# **SIX COUNTY SC LIDAR QUALITY ASSURANCE**

## **ABBEVILLE COUNTY REVIEW**

**UNITED STATES GEOLOGIC SURVEY  
AND  
SOUTH CAROLINA DEPARTMENT OF NATURAL RESOURCES**

Final review: February 6, 2013

*Figure 2: Overall project flight line exhibit (left) and enlarged view (right)*

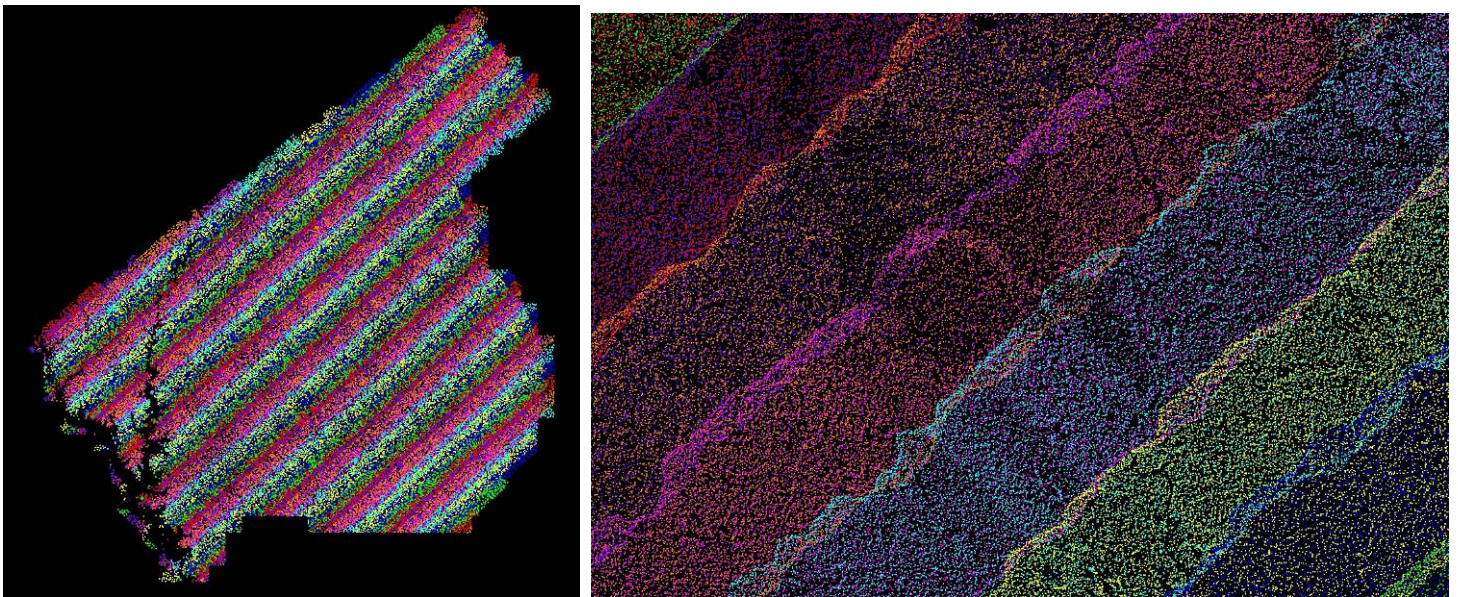
The first item outlined in the Criteria states that flight lines are directed to be flown as planned with 45% minimum overlap between flight lines and a maximum flying height of  $\approx 8,300$  ft AMT. According to the metadata, the flight lines were flown with a sidelap of 50% with a target altitude of 1,500 meters (4920') and based on the stated flight parameters meet the criteria. Additionally, the Positional Dilution of Precision (PDOP) needed to be less than 4, and the collected data could not have holidays. The flightlines were visually checked for gaps and assured that they contained enough sidelap. Also, the flight collection was required to have periodic and local calibration checks. The figures below show the extents of overlap:

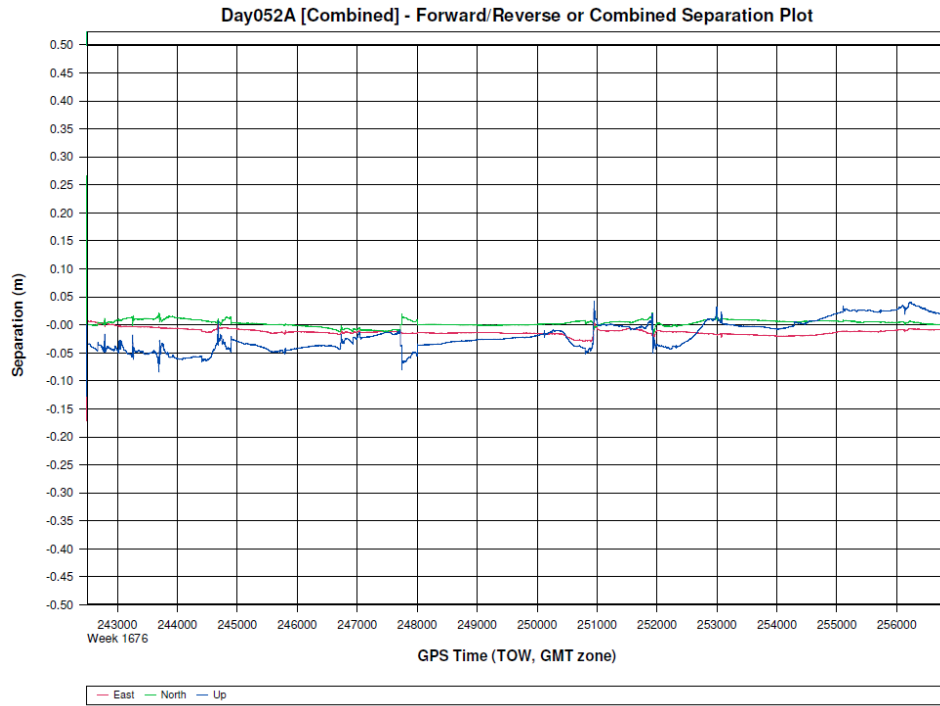
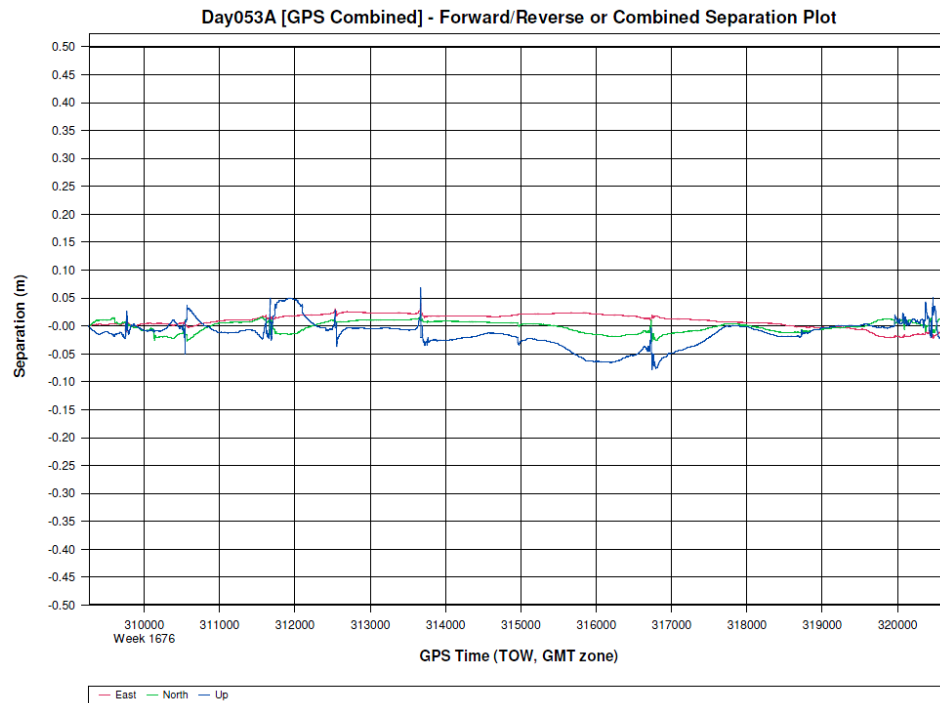
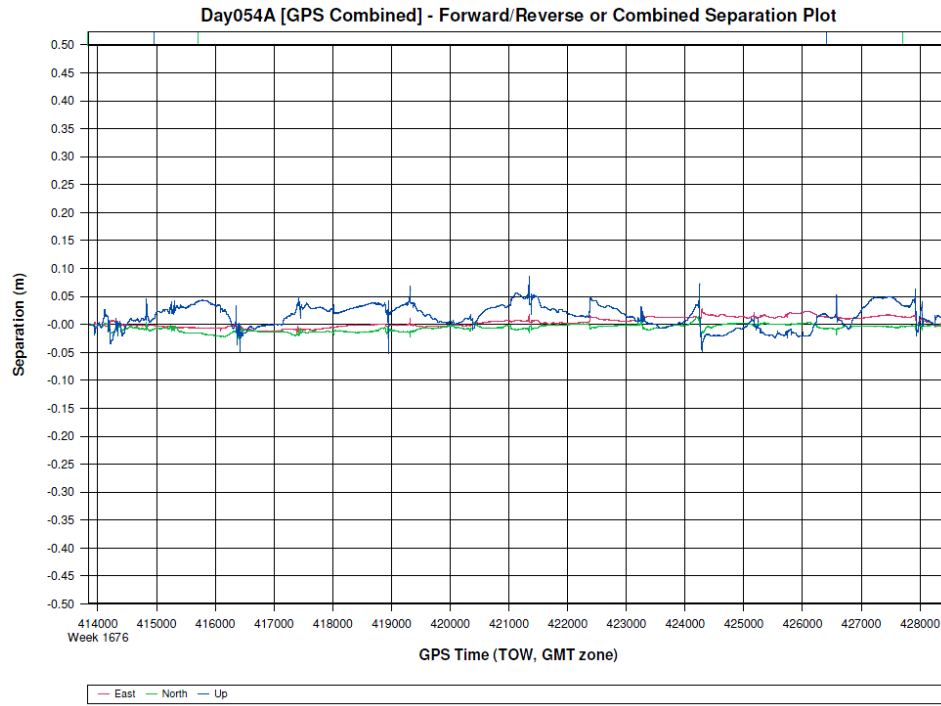
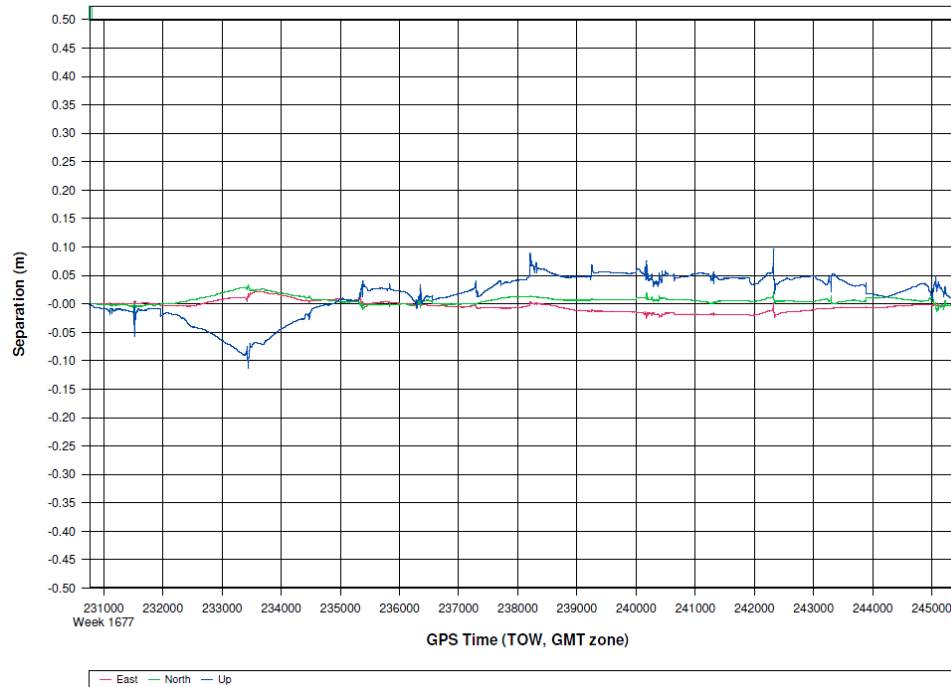
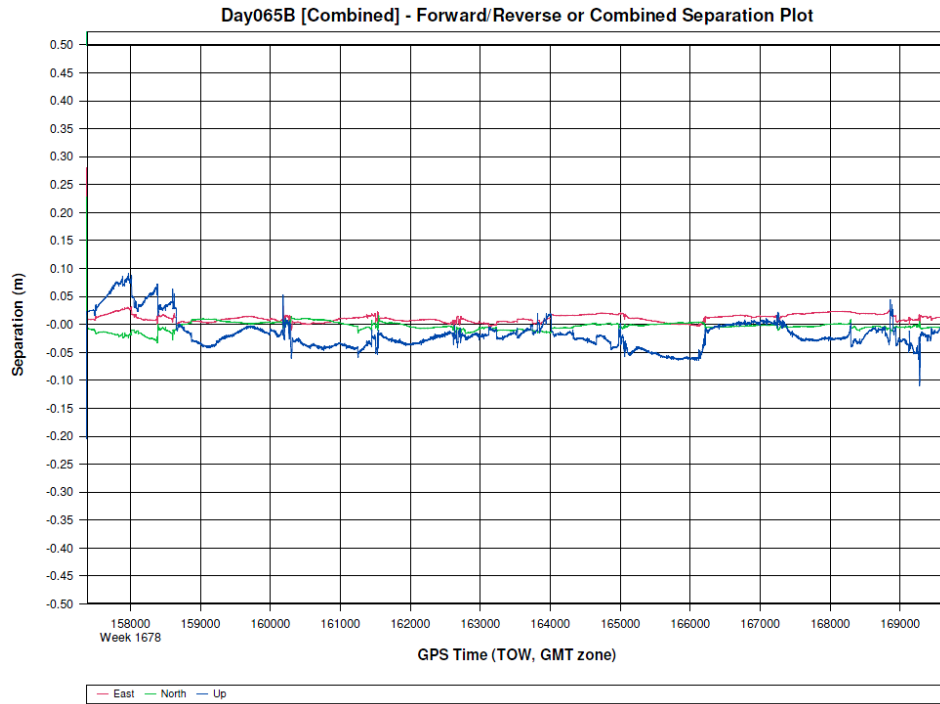
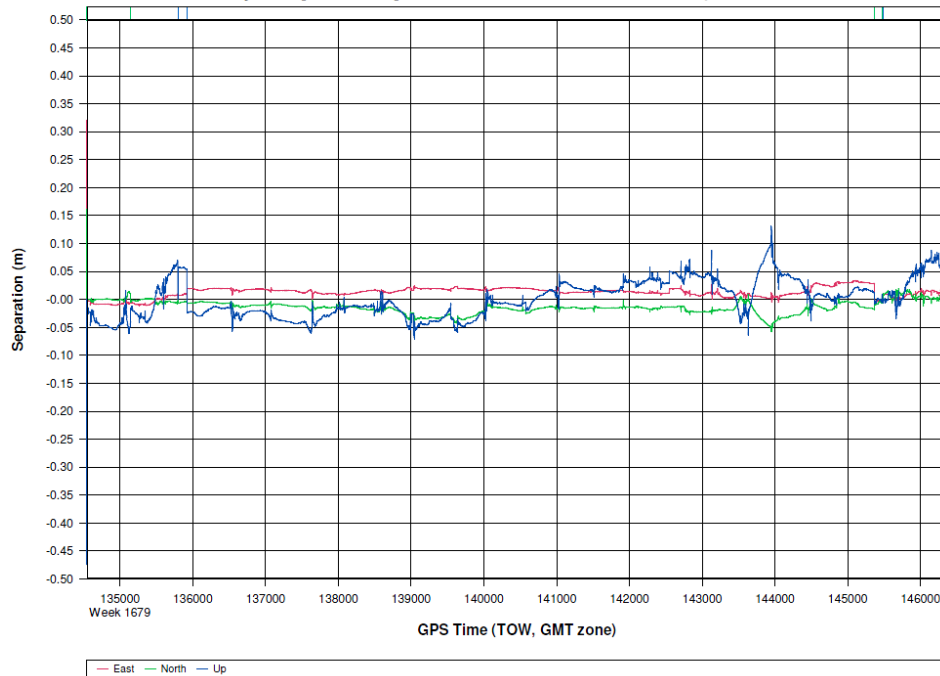
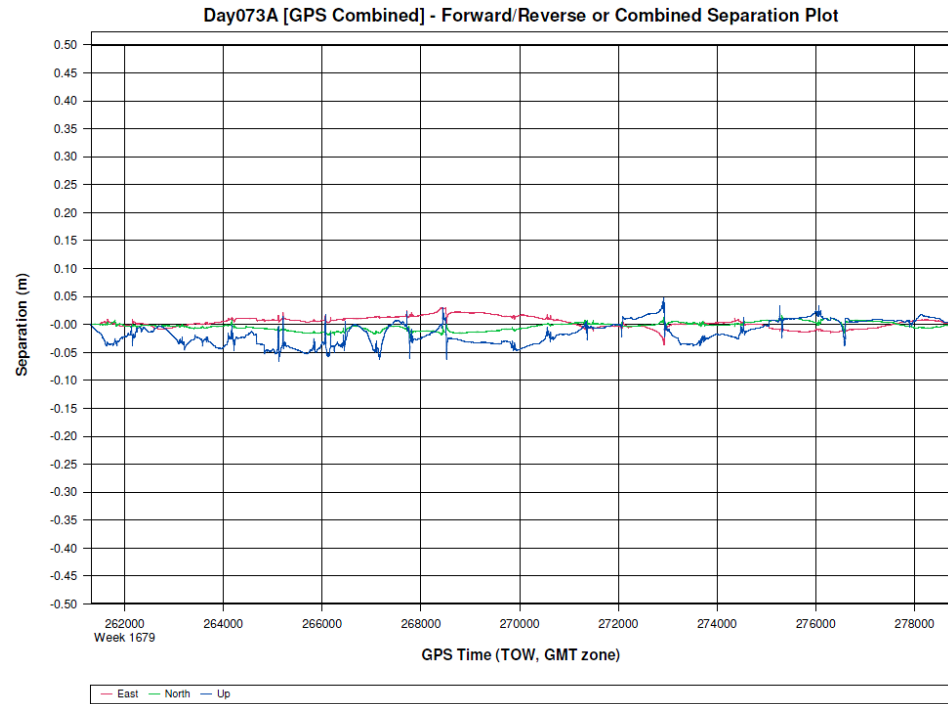
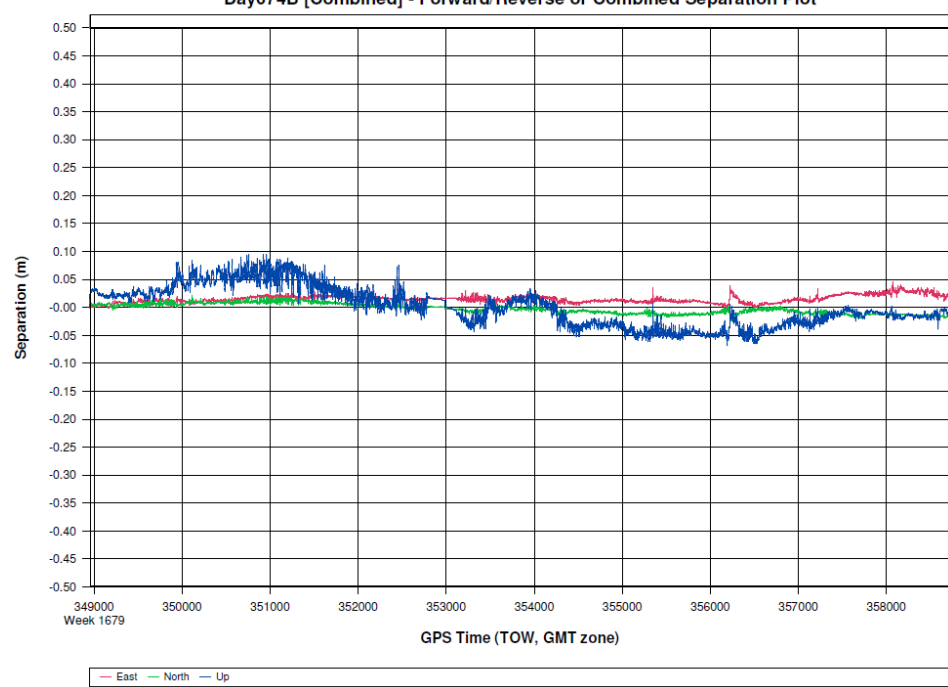
Additionally, the Criteria require the GPS trajectories to be evaluated with forward and reverse comparisons within 10-20 cm. The GPS solution charts are provided in the Appendix of this report and conform to the Criteria. The GPS solution charts below represent the Combining of the forward GPS solution and the reverse solution. The forward solution is the processing of the GPS data from the start of a mission to the end of a mission. The reverse solution is the processing of the GPS data from the end of the mission to the start of a mission. The red line represents the combined solution in relationship of the east component of the data. The green line represents the combined solution in relationship to the north component of the data. The blue line represents the combined solution of the vertical component of the data. In *figure 11*, it should be noted that the vertical component (blue line) appears to be very noisy and jagged, this is a result of a less dynamic solution of the vertical agreement between the forward and reverse GPS solution of the data. In simple terms the vertical component of the data did not agree as well as in the other *figures (4-11)* but is well within the required tolerances. This is not an indication of an error in the data but representing a difference in the two solutions. Providing, the GPS Combined solution is within tolerance as required this will not affect the overall LiDAR Data.
